Repair of Panel N39 and Placement of Geotextile and Armor Stone in Panels N37, N38, and N39

PREPARED BY: George Hicks, CH2M HILL

DATE: April 14, 2014

Figure 1

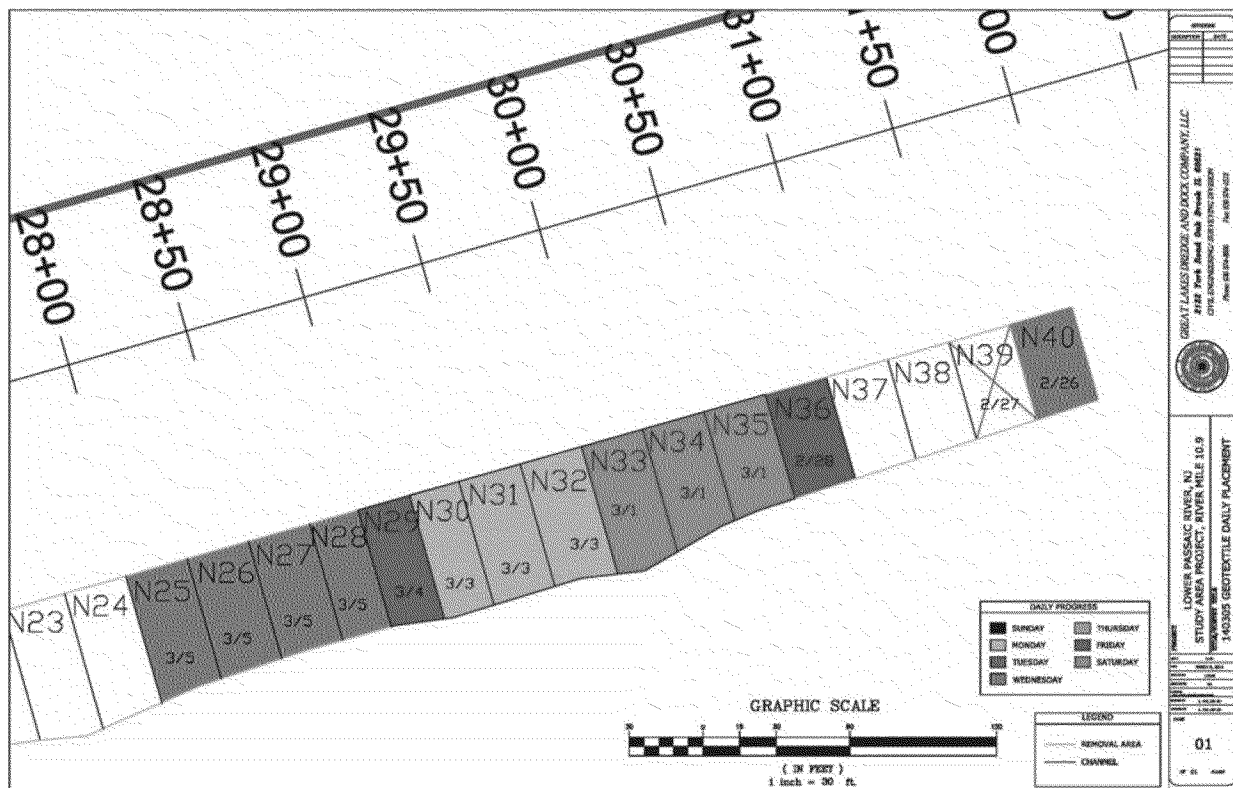
During placement of geotextile panel N39 on the northern end of the cap area (Figure 1), the geotextile panel and armor stone placed on top of the geotextile slid down the slope. Subsequently, the geotextile/armor stone which accumulated at the bottom of the slope was removed on March 31, 2014. The following sections outline the proposed means and methods to repair the N39 area and place geotextile and armor stone in uncompleted panels N39, N38, and N37.
